Equitable Building Manchester

Planning Conditions Discharge Report

24105-R02B-BT

Figure 3: FCU Layout

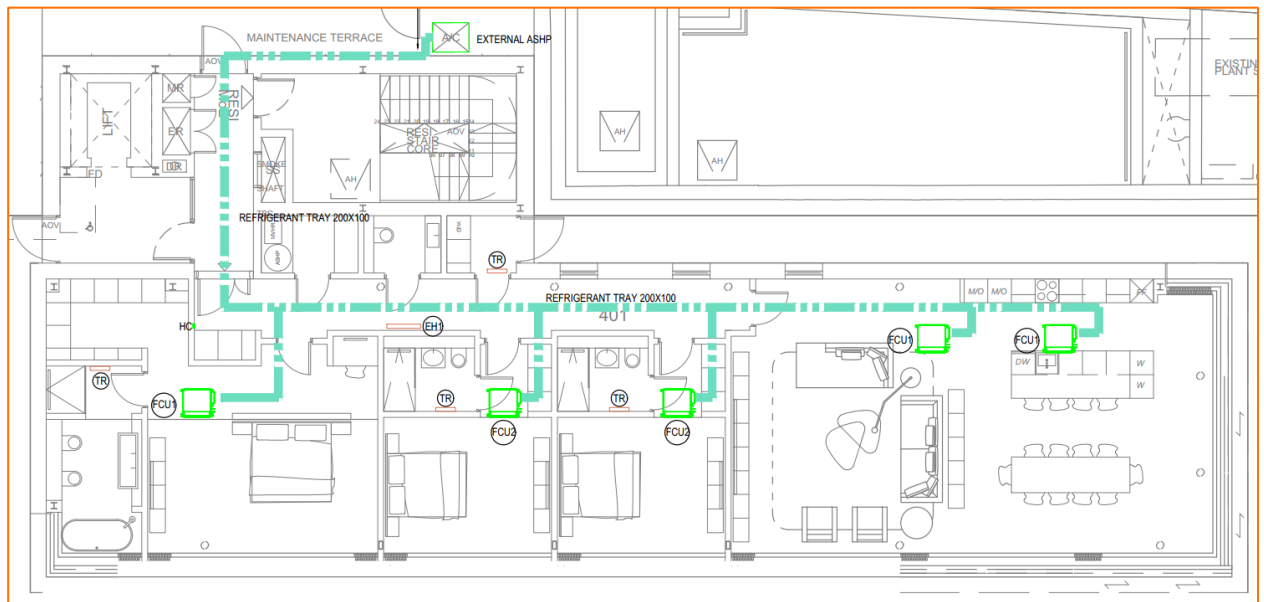
“Once the ventilation system has been selected, we will need an assessment of the noise level from the system and insulation recommendations to ensure that when in full use (including any boost function where applicable) it does not lead to an exceedance of the internal noise criteria.”
- 2.2 This is unusual, and Manchester City Council’s (MCC) conditions usually relate to noise ingress only. A methodology for indoor ambient noise level verification measurements has been agreed with Manchester City Council which explicitly states that mechanical services noise is switched off during measurements.
- 2.3 The associated condition is reproduced below, which appears to confirm this relates to noise ingress only;

2.12 On the fourth floor, FCUs are also located in bedrooms and living rooms, as indicated in Figure 3, below.

2.14 Calculations indicate that noise levels in rooms served by FCU1 would be around 28dBL_{Aeq,T}, and hence meet the recommended noise limits.

2.15 For the bedrooms served by FCU2, noise levels would be around 35dBL_{Aeq,T}, and hence exceed the recommended limits.

2.16 A basic 600mm long 50% free area attenuator would reduce this to around 25dBL_{Aeq,T}, and hence meet the recommended limits.

Figure 5: Nearby Noise Sensitive Receptors

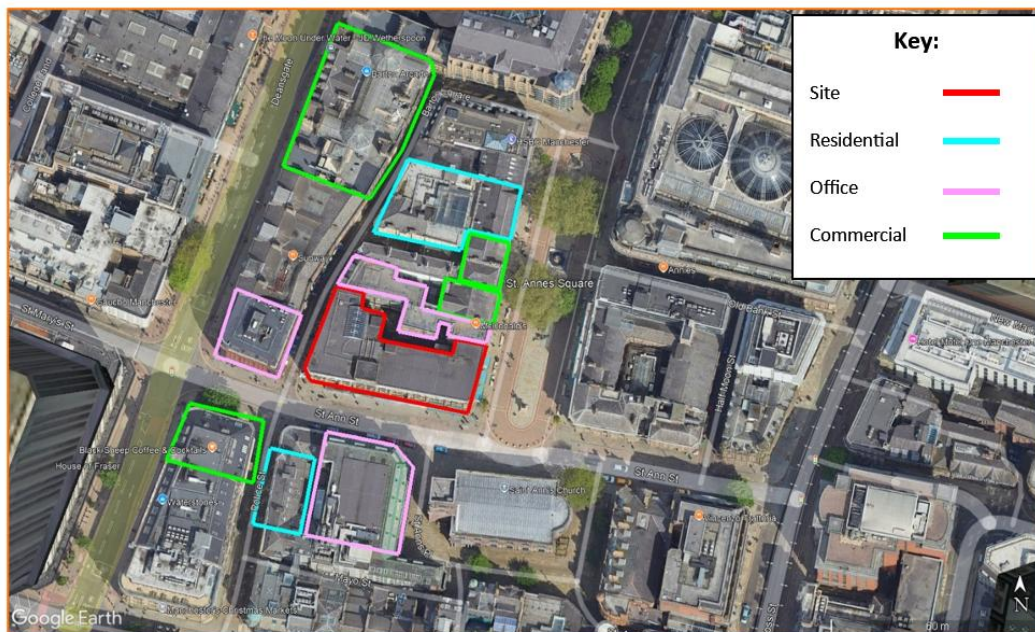
“The plant has yet to be selected and the report includes recommended plant limits for once the plant has been selected. However, the plant limits proposed would not comply with the above condition as plant limits equal to the LA90 have been proposed which is not acceptable. Plant and equipment, including any plant located behind louvres or grilles will need to be selected and treated to not exceed 5dB below the LA90 at the proposed residential receptors and the nearby commercial properties so section 4.5 will need to be revised accordingly.”

6.5 The nearest noise sensitive receptors are believed to be as shown in Figure 5, below.

- 6.10 Calculations indicate that without mitigation, noise levels at the western NSR would be around $52\text{dBL}_{\text{Ar,Tr}}$, and at the northern NSR, around $61\text{dBL}_{\text{Ar,Tr}}$. These calculations are based on all units running simultaneously.

- 6.11 These noise levels therefore exceed the required noise limits.
- 6.12 Calculations indicate that a 600mm long attenuator with a 50% free area fitted to both the inlet and outlet paths would achieve a specific noise level of around $48\text{dBL}_{\text{Aeq,T}}$ at the nearest NSR to the north.

- 6.13 There is no indication of tonality in the noise data provided (Figure 1), and hence even allowing a +3dB for potential intermittency, the worst-case rating noise level would be $51\text{dBL}_{\text{Ar,Tr}}$, which meets MCC's requirements.

- 6.14 To the west the rated noise level would be around $42\text{dBL}_{\text{Ar,Tr}}$, and hence meet Manchester's requirements.
- 6.15 To the residential receptors at the north of the site, due to the additional distance and screening, the rating level at the nearest window would be around $35\text{dBL}_{\text{Ar,Tr}}$, which meets MCC's requirements at any time of day or night.

Figure 6: Typical Ventilation Layout

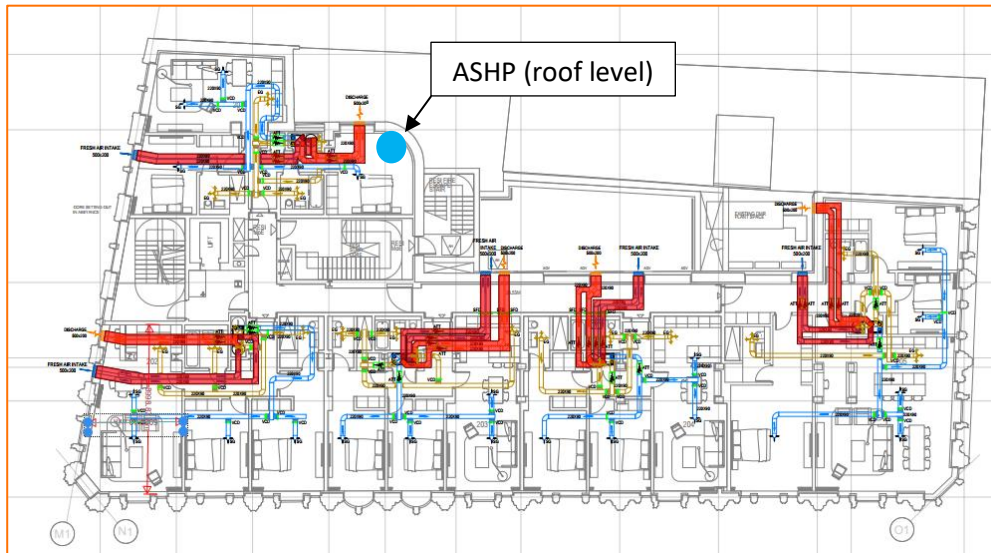
6.7 A typical floor ventilation layout is shown as Figure 6, below

- 6.8 Overall, there are 7 inlets and 9 outlets on the northern elevation, along with the ASHP, and 4 inlets and 2 outlets on the western elevation.
- 6.9 The nearest noise sensitive receptors are all offices. These would therefore only be expected to be in use in the day, and hence a limit of $51\text{dBL}_{\text{Ar,Tr}}$ would apply.
